**Addendum #2 - Issued on May 27, 2010**

Regarding Bids for the **Port Lawrence Bus Shelter (ITB 10-002P)** through the Lucas County Administrator's Office, bid opening scheduled for June 2, 2010.

**Date:** May 27, 2010  
**Project Title & Location:** Port Lawrence Bus Shelter  
Toledo, Ohio  
**Project No.** 16591M0

ADDENDUM NO. 2

1  
**INTERIOR WALL FOOTINGS**  
 SKA5.01.A SCALE: 1/4" = 1'-0"

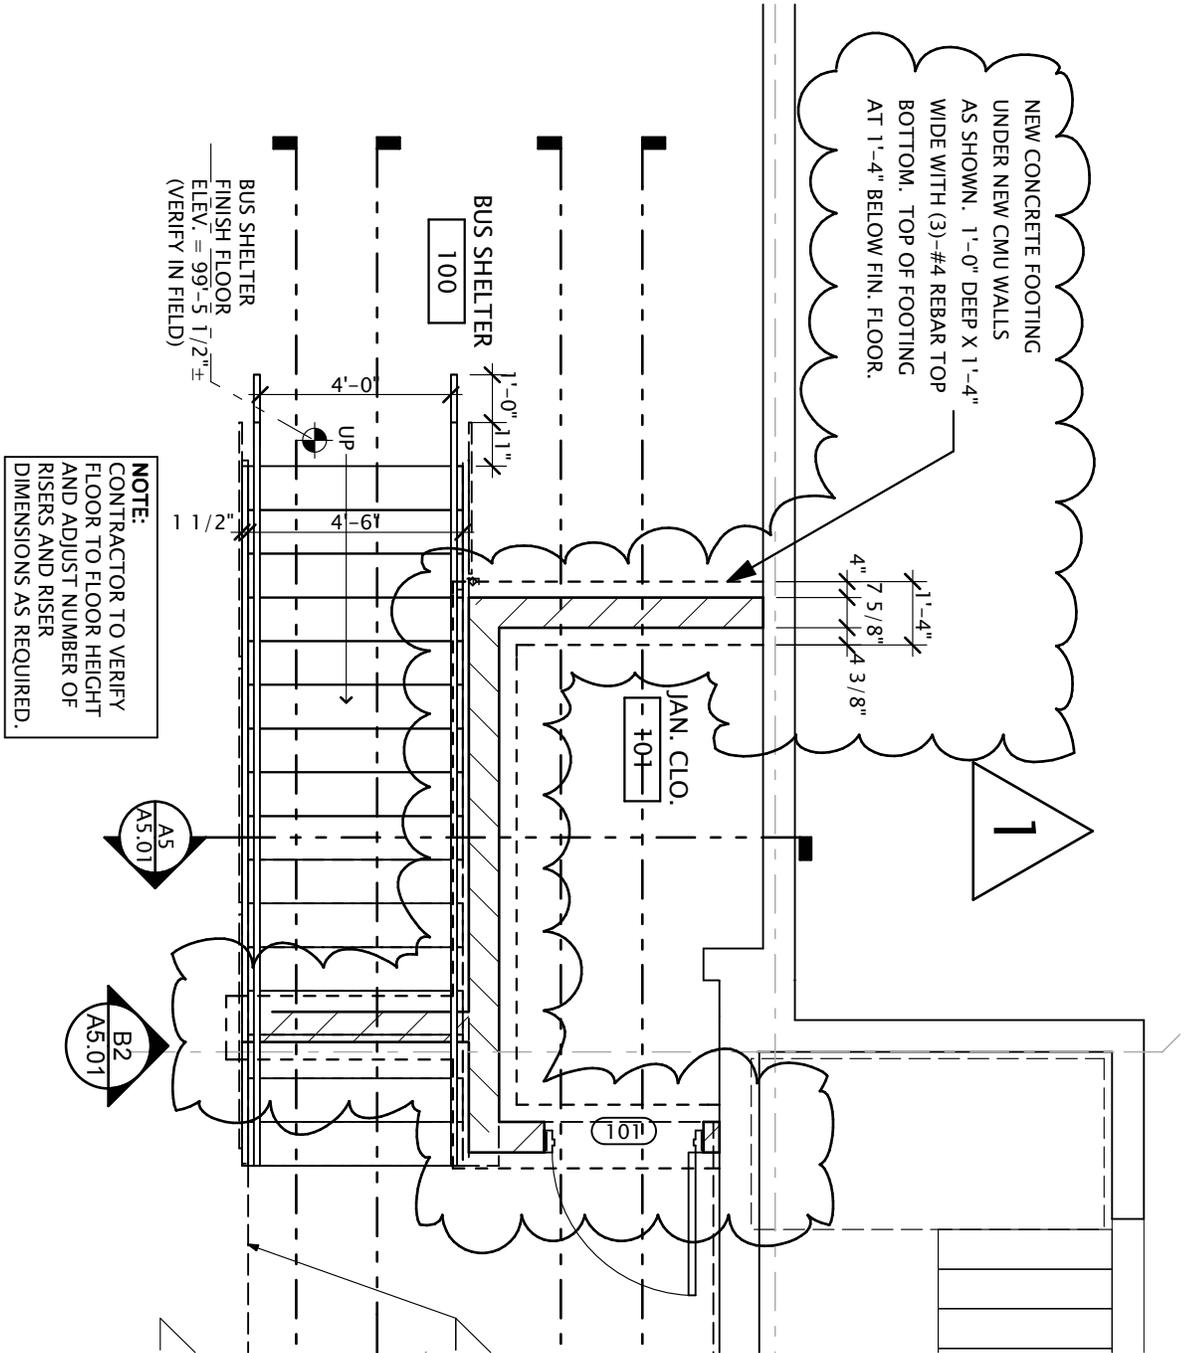
Item #1 – Add new concrete strip footing under concrete masonry walls around and adjacent to “Jan. Clo 101”. Cementitious material shall be Portland Cement Type I/II, normal weight aggregates, and minimum 3,500 psi at 28 days.

3	Interior masonry walls for mech room and stairs – Foundation requirements – can these walls be installed on existing concrete slab	The interior masonry walls around Mechanical 102 extend to a height of 9'-4" above finish floor. Above that height the wall is framed with metal studs and gypsum board. No footing is required at this location. Footings will be required under the new concrete masonry walls around JAN / ELECT 101 and under the new stair. See sketch SKA5.01.A in Addendum #2 for additional information.	Mosser	TCI	Addendum #2
4	Drawing A1.02 – Third Floor shows relocated surface mounted FEC- where is the existing cabinet located	The existing surface mounted FEC is currently located on the masonry wall to be removed near the location of new door 301.	Mosser	TCI	Addendum #2
5	Substitution Request - Sun Control Devices	American Warming and Ventilating is approved as manufacturer for sun control devices under specification Section 10-7113, Section 2.3. Refer to included substitution sheet and commented request form for additional requirements.	Architectural Elements	TCI	Addendum #2

<b>american warming and ventilating</b> A MESTEK COMPANY 7301 INTERNATIONAL DRIVE HOLLAND, OHIO Phone (419) 865-5000 Fax (419) 865-1375		
<b>SCL-4-A SUN CONTROL LOUVER</b>		
DRN. BY	DWG. NO.	REV.
JVC	<b>SCL-4-A</b>	
DATE		
6/3/04

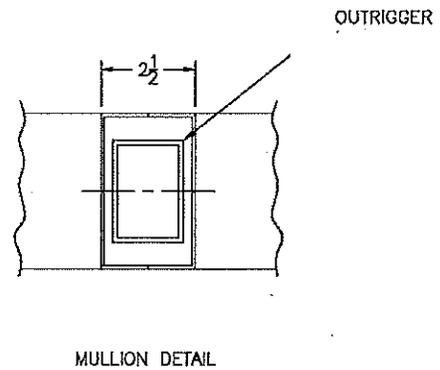
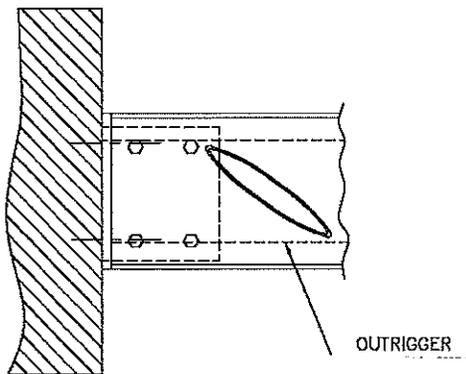
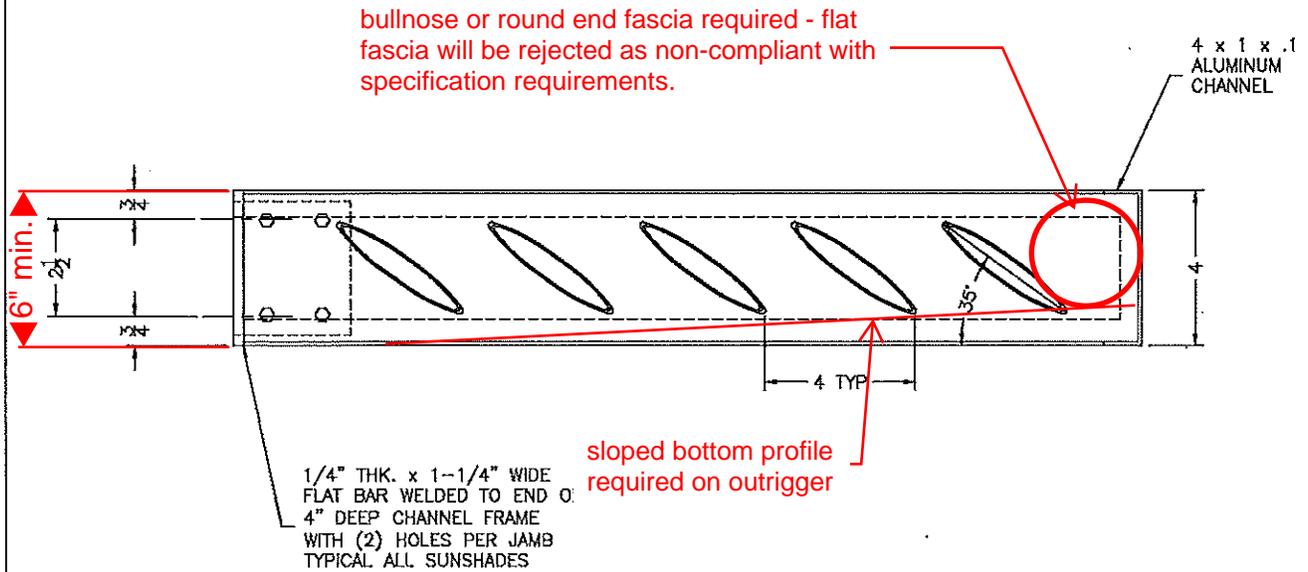
Specification Section and Paragraph: 10 7113 EXTERIOR SUN CONTROL DEVICES PARAGRAPH 2.1

Proposed Substitution Description: ADDING AMERICAN WARMING & VENTILATING AS AN ACCEPTABLE MANUFACTURER

<input type="checkbox"/>	Accepted	<input checked="" type="checkbox"/>	Accepted As Noted
<input type="checkbox"/>	Not Accepted	<input type="checkbox"/>	Received too late to review
<input type="checkbox"/>	Incomplete Information	<input type="checkbox"/>	
<input type="checkbox"/>	No Substitution Allowed for specified item	<input type="checkbox"/>

Comments: Product must have same outrigger profile shown on drawings, a rounded fascia and air foil blade size complying with specification requirement in Section 107113, Part 2.3, Item D.
